Board of Examiners of Water Well Construction
and Pump Installation Contractors

NOTICE OF GENERAL MEETING OF THE BOARD OF EXAMINERS
AGENDA

Date April 1, 2025

Permit 121356 - Vicinity Map

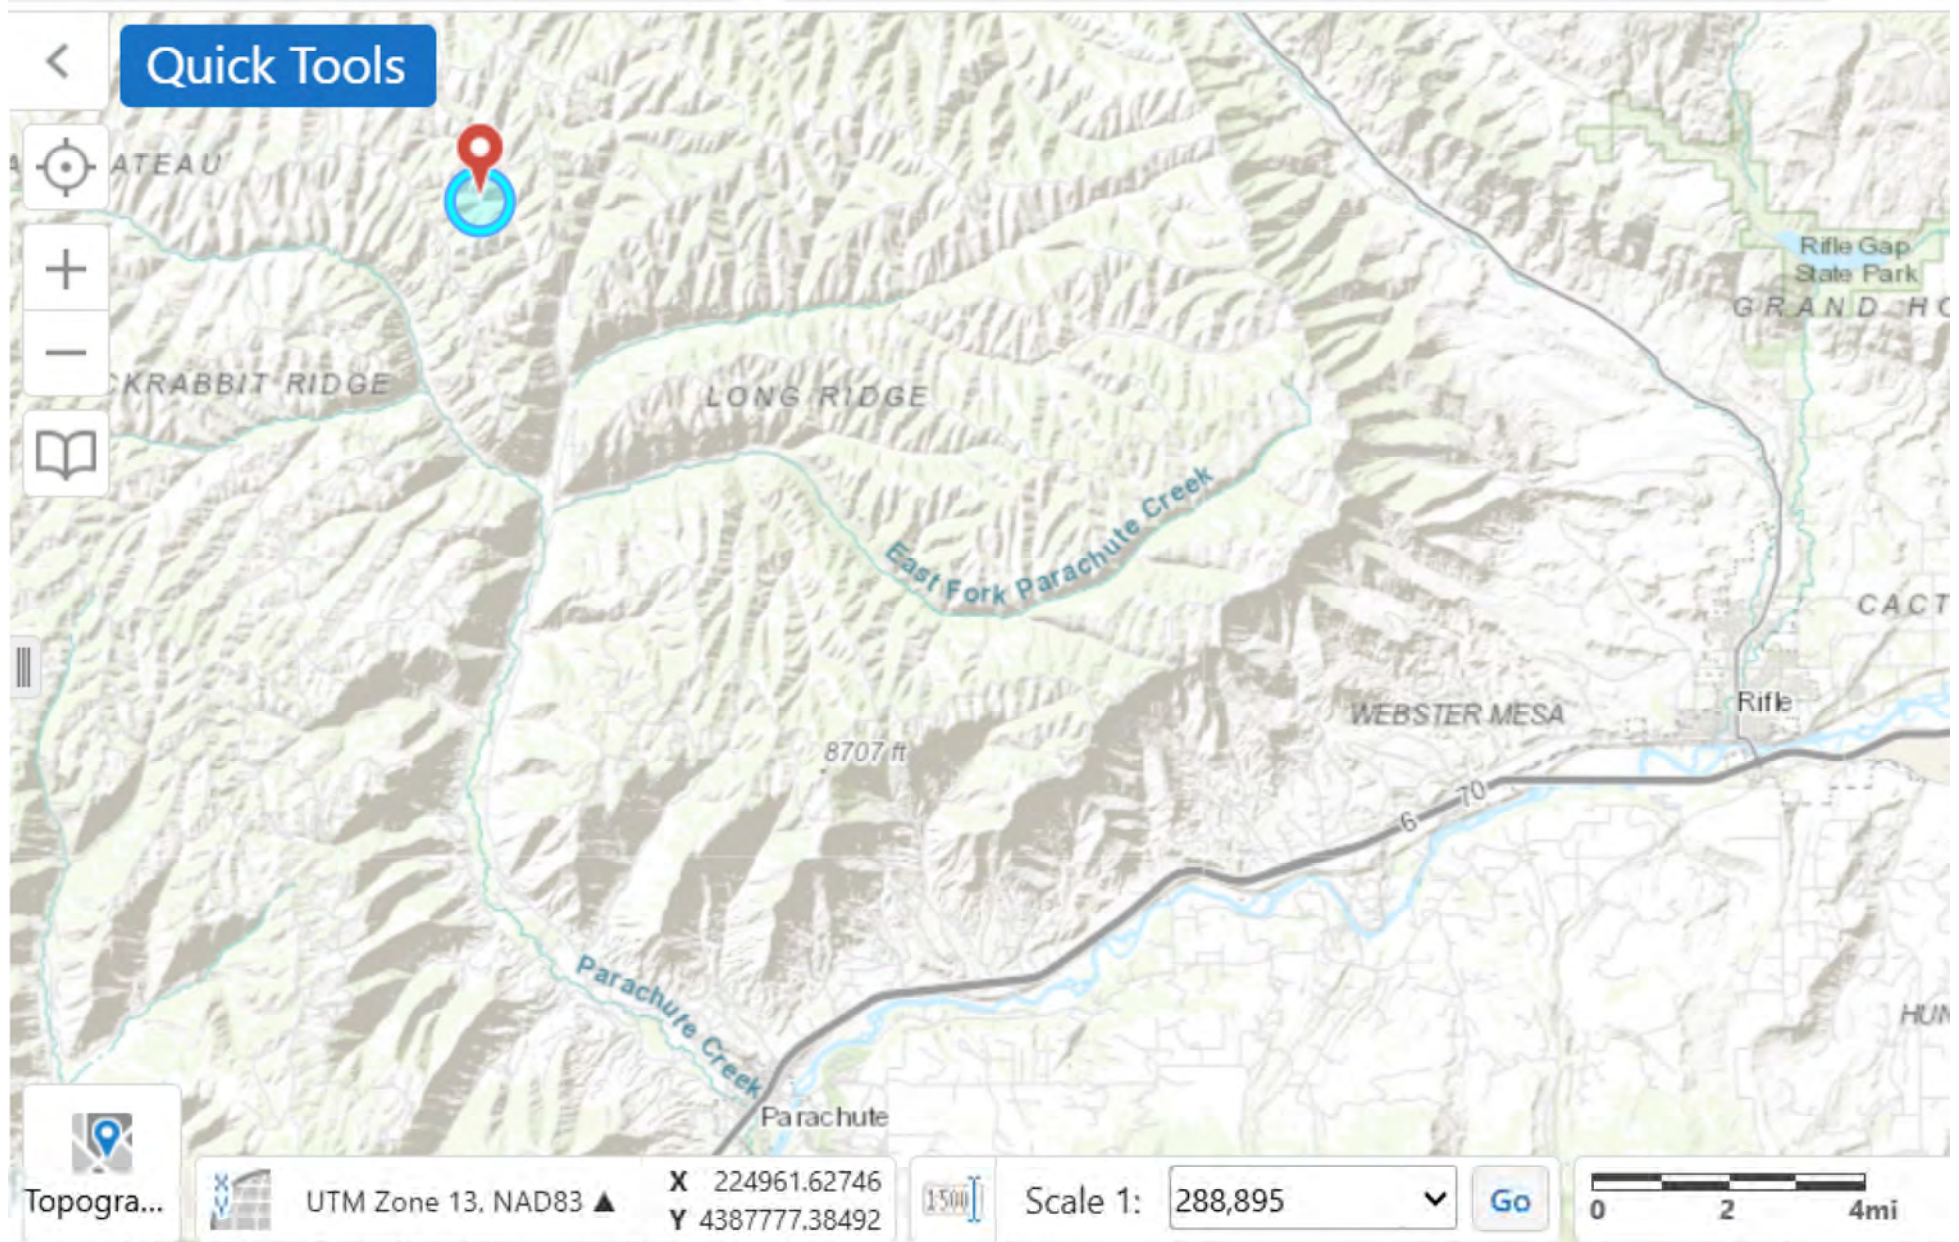
- The variance request opines on the owners intent based on the response “licensed” to question 4 of the permit application asking about the proposed “driller” as being in good faith. The intent of the owner to have the well constructed in accordance with the rules and regulations of the Board from his response to question 4 of the application is conjecture. The owner’s apparent neglect to follow the requirements of the Rules allowing only a contractor licensed by the Board to construct water wells or test holes at the time this well was constructed is a self inflicted hardship and is not a valid practical difficulty or unusual hardship in the Board Staff’s opinion.

Permit 121348 - Vicinity Map

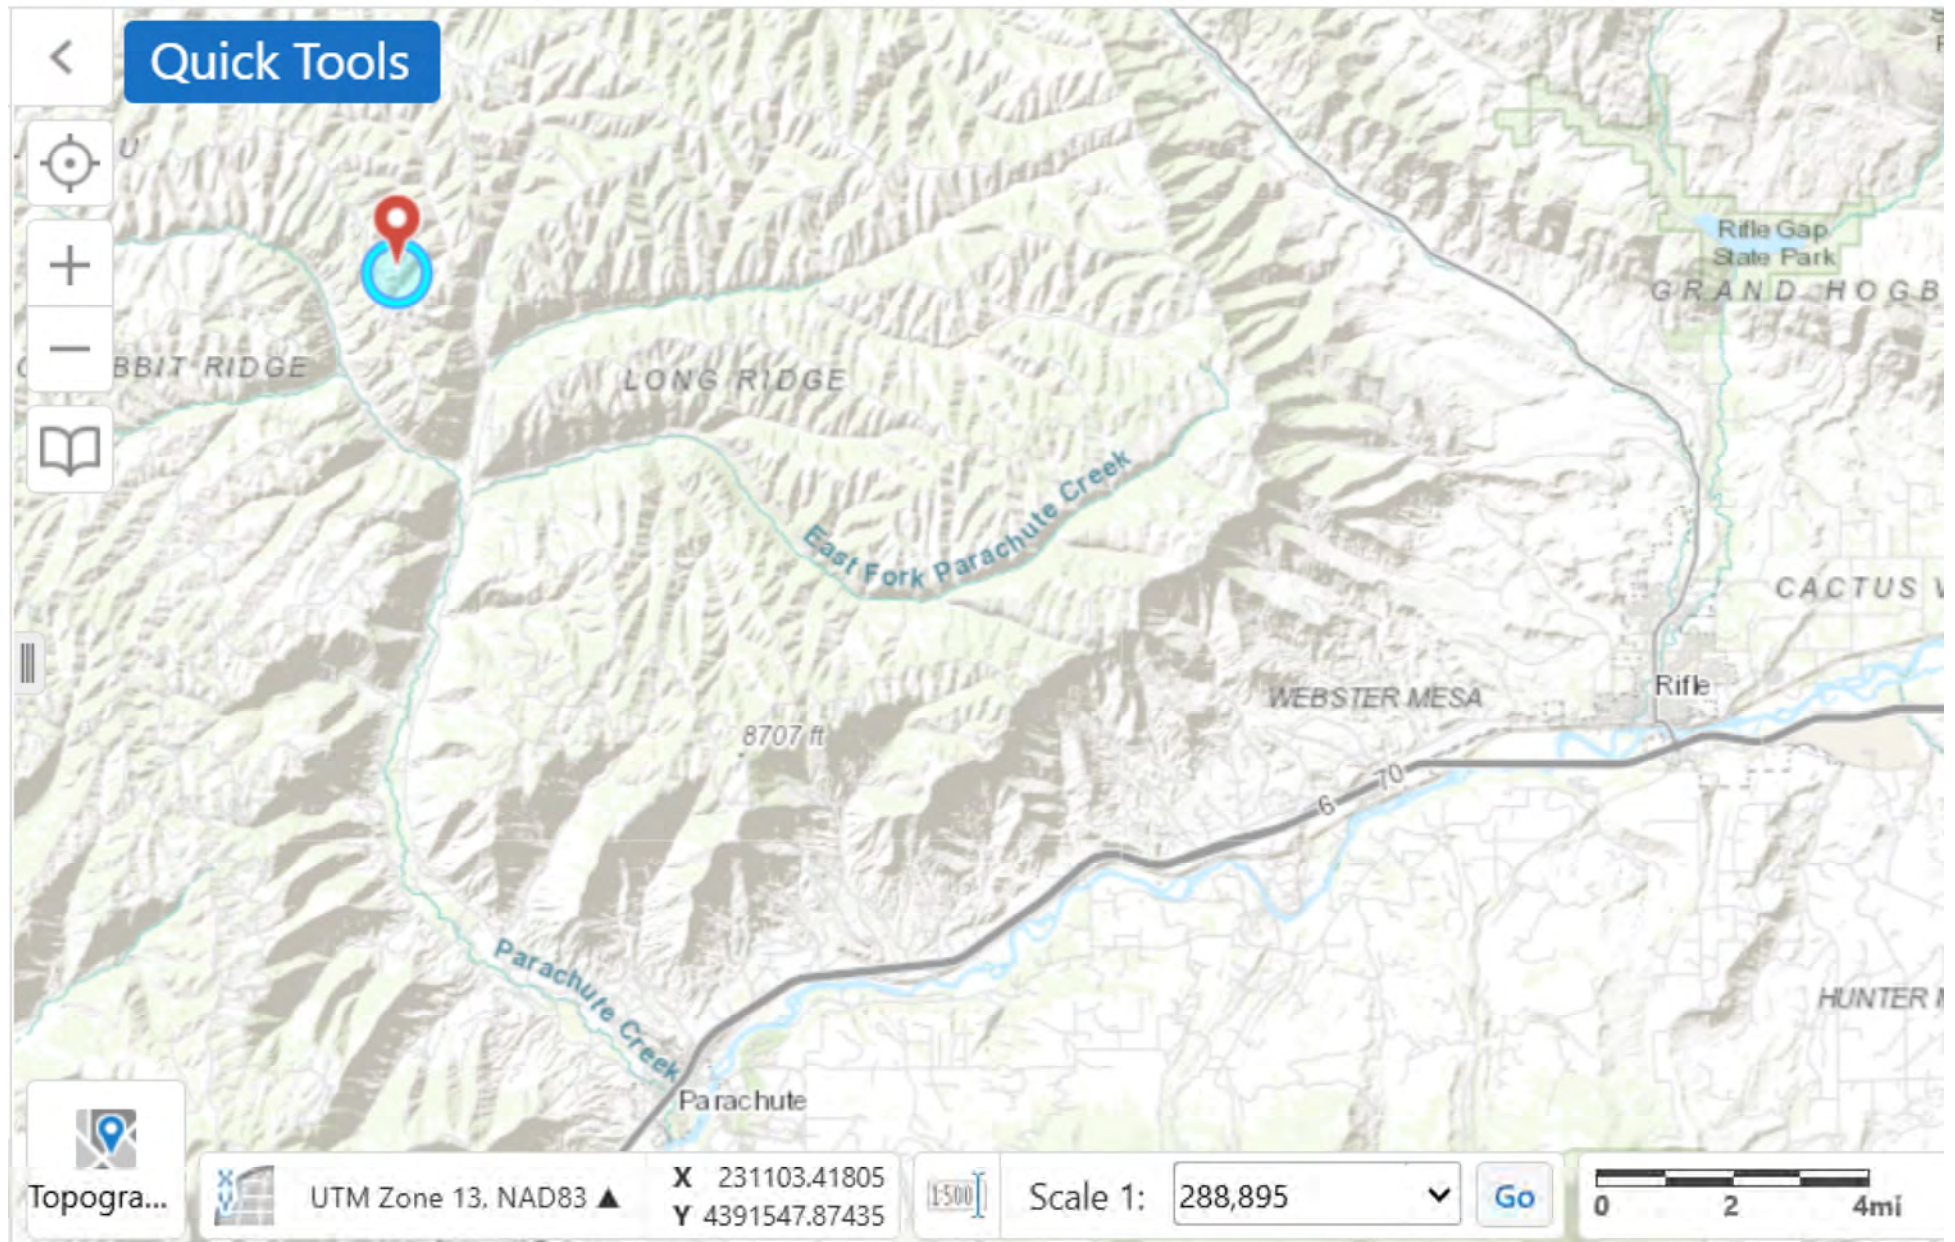
- The variance request opines on the owners intent based on the response “licensed” to

question 4 of the permit application asking about the proposed “driller” as being in good faith. The intent of the owner to have the well constructed in accordance with the rules and regulations of the Board from his response to question 4 of the application is conjecture. The owner's apparent neglect to follow the requirements of the Rules allowing only a contractor licensed by the Board to construct water wells or test holes at the time this well was constructed is a self inflicted hardship and is not a valid practical difficulty or unusual hardship in the Board Staff's opinion.

Permit 164780 - Vicinity Map

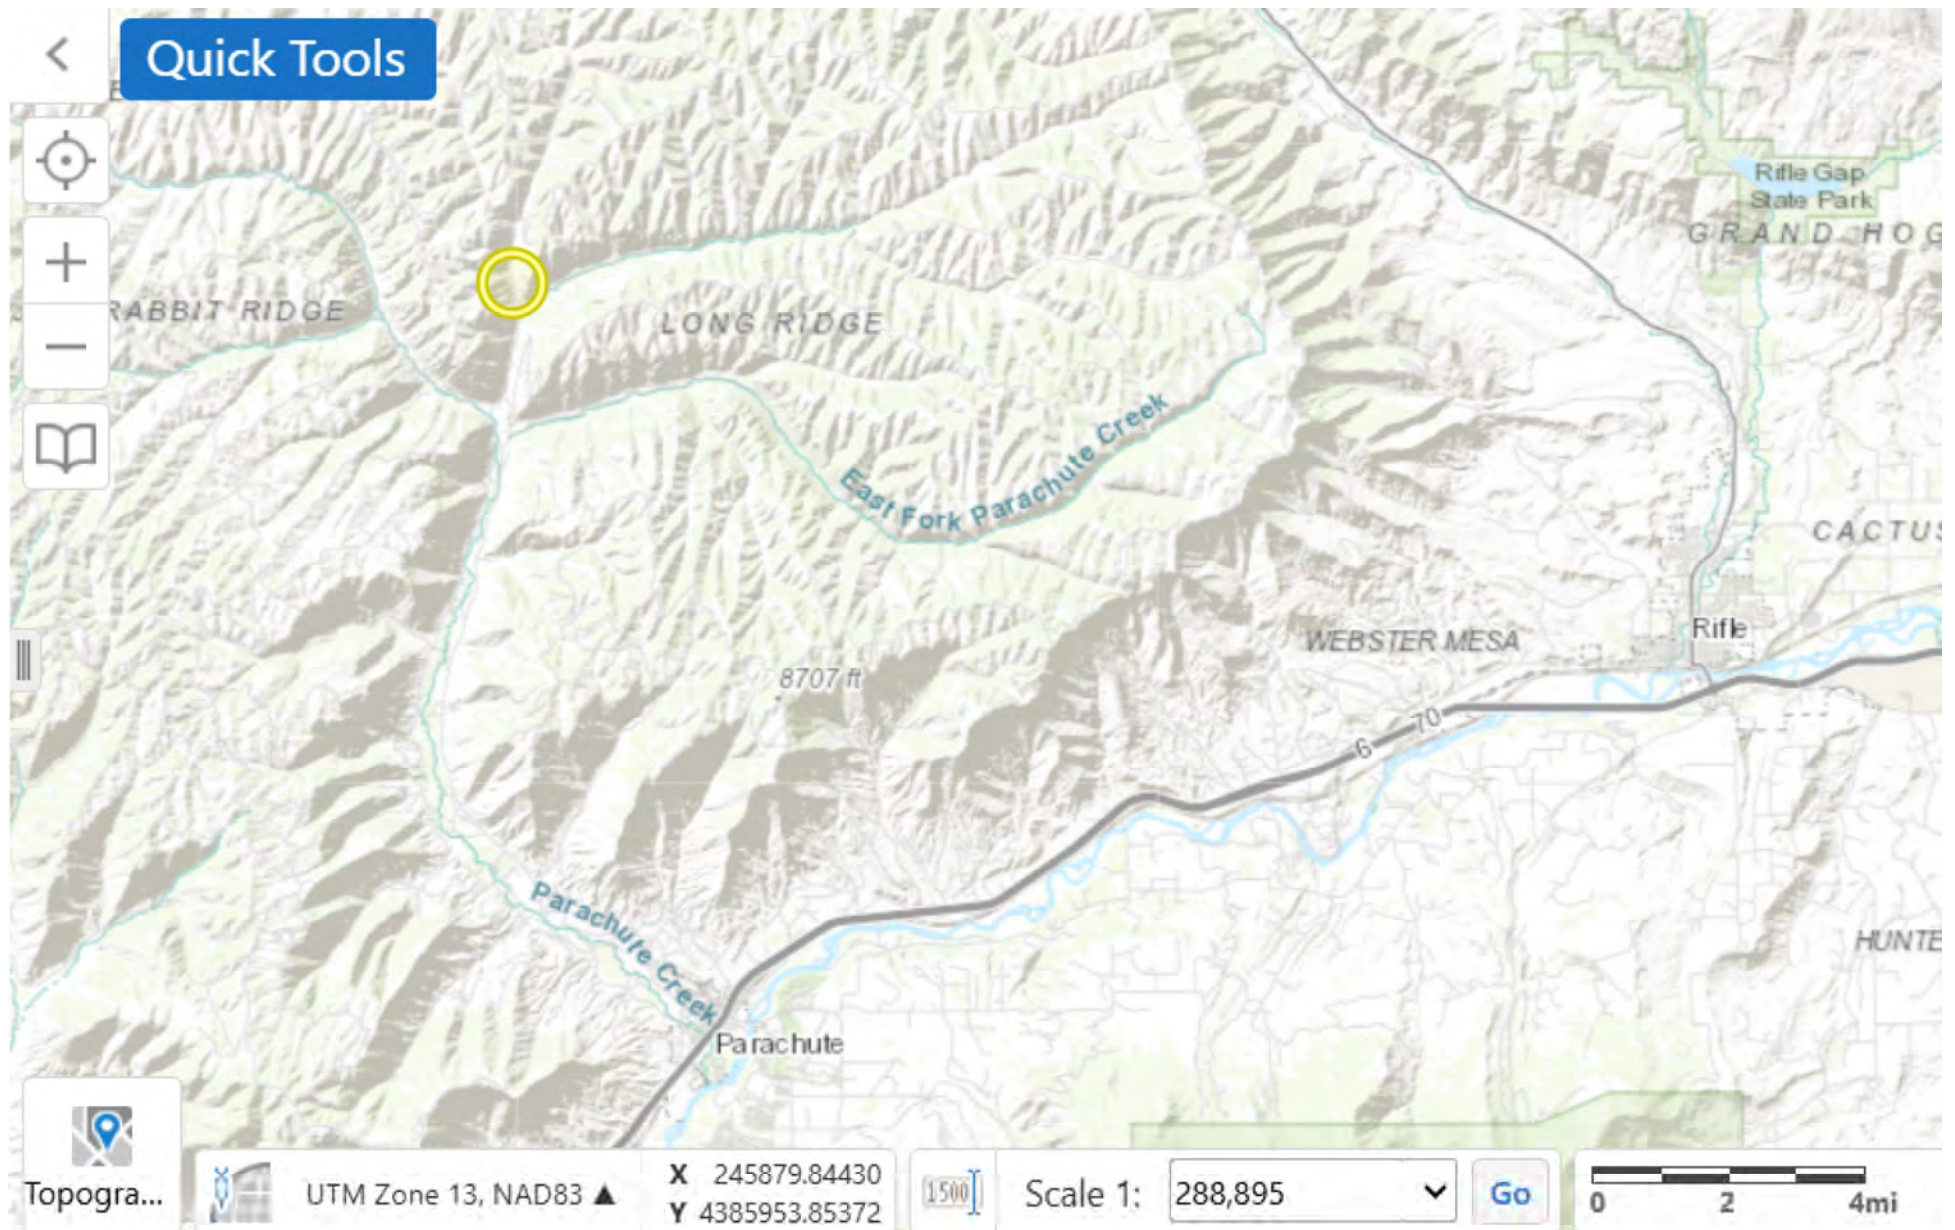
- Perforated PVC wall thickness was reported as 0.02 inches which is less than 0.200 inches required by 10.3.5.1.b for a water well. Though this might be a typo, the information presented on the form does not show compliance with the well construction Rules in place at the time of construction.

The construction information on Form GWS-31 is not approved for the proposed conversion to a production well due to the above described aspects of the construction not meeting the standards for a water well at the time of construction, and because repairs do not appear feasible to bring the well into compliance with the minimum water well construction standards of the Rules in place at the time of construction. If you have other information that may clarify or correct our understanding of the well please send it to this office.

Permit 164914 - Vicinity Map

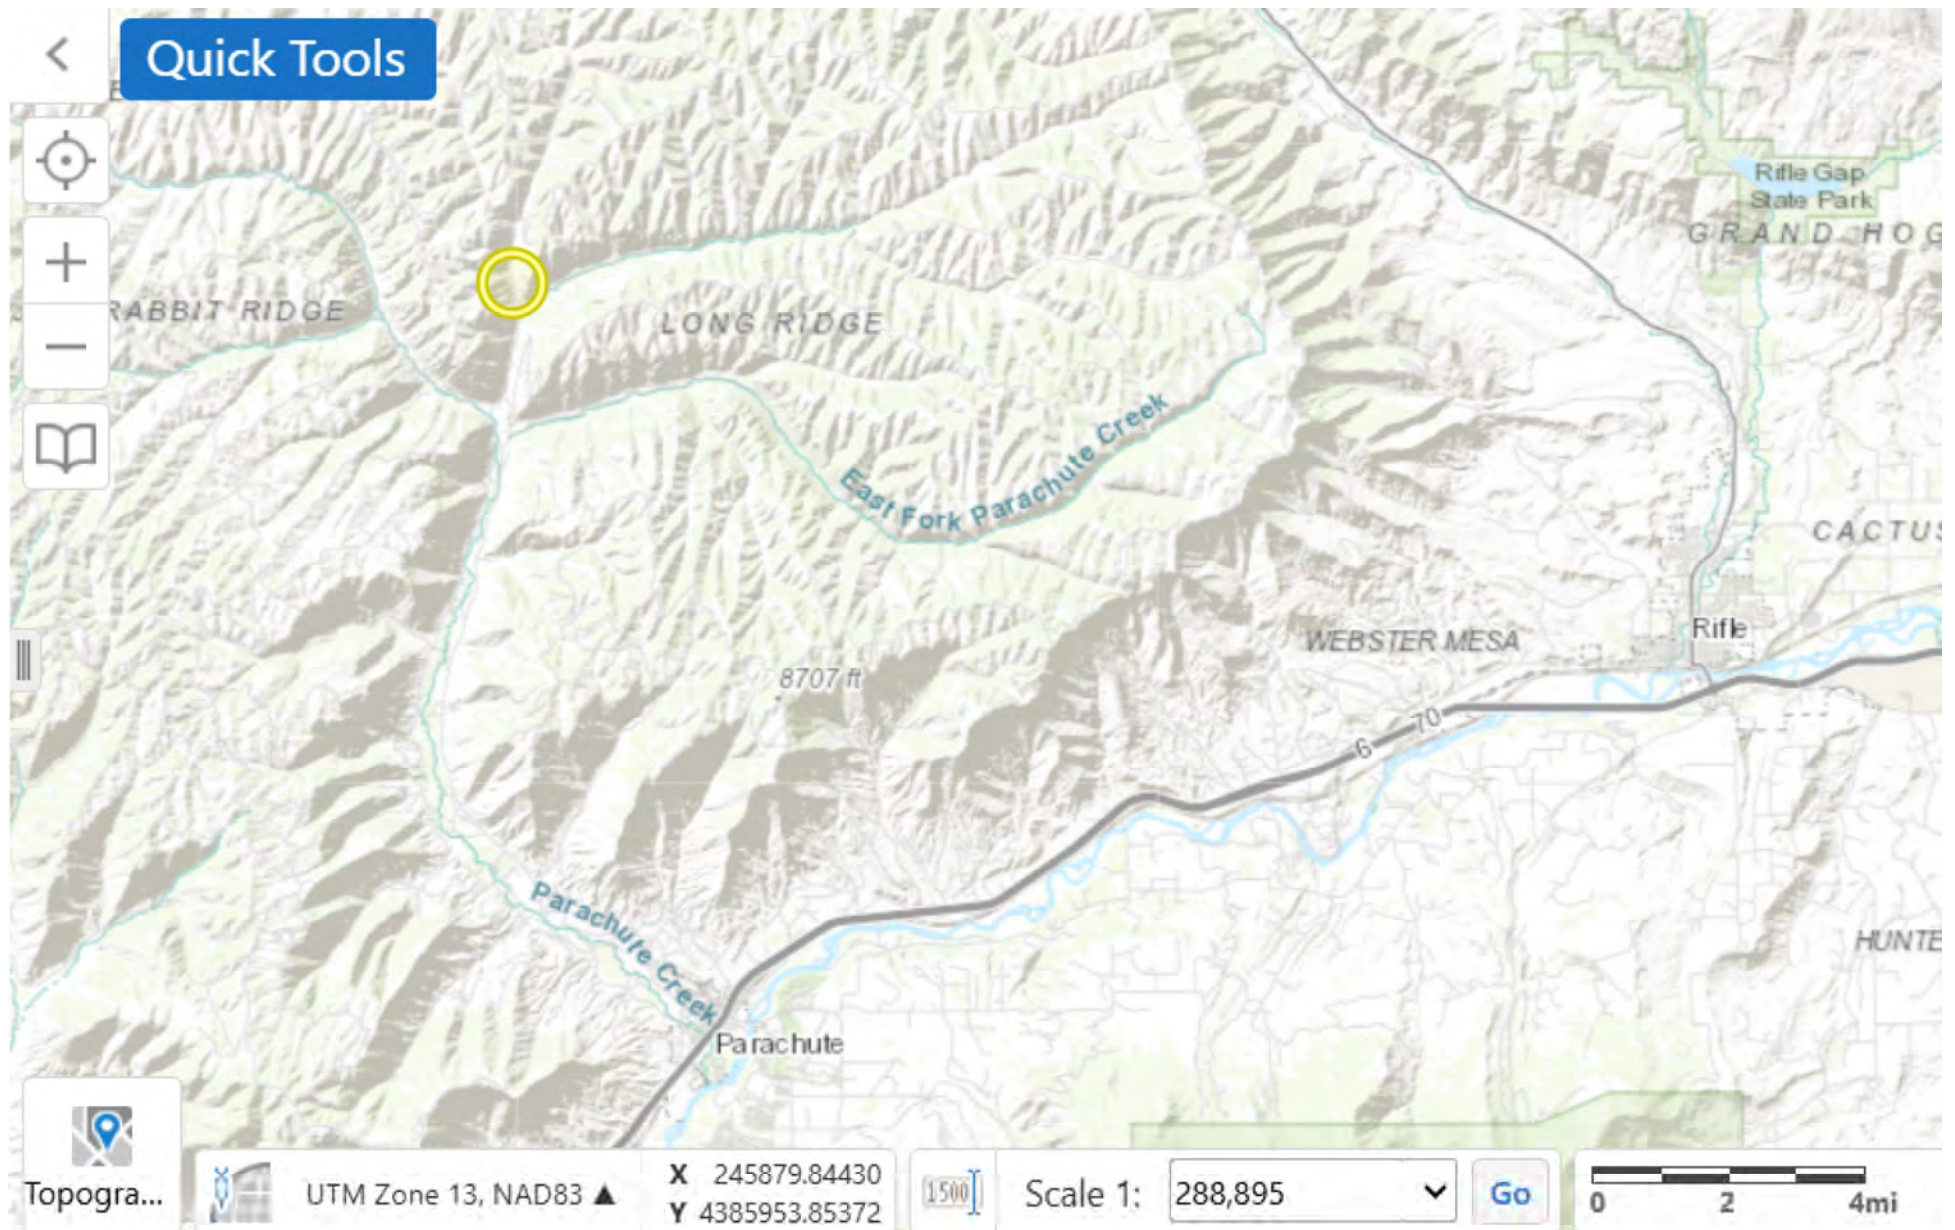
- Perforated PVC wall thickness was reported as 0.02 inches which is less than 0.200 inches required by 10.3.5.1.b for a water well. Though this might be a typo, the information presented on the form does not show compliance with the well construction Rules in place at the time of construction.
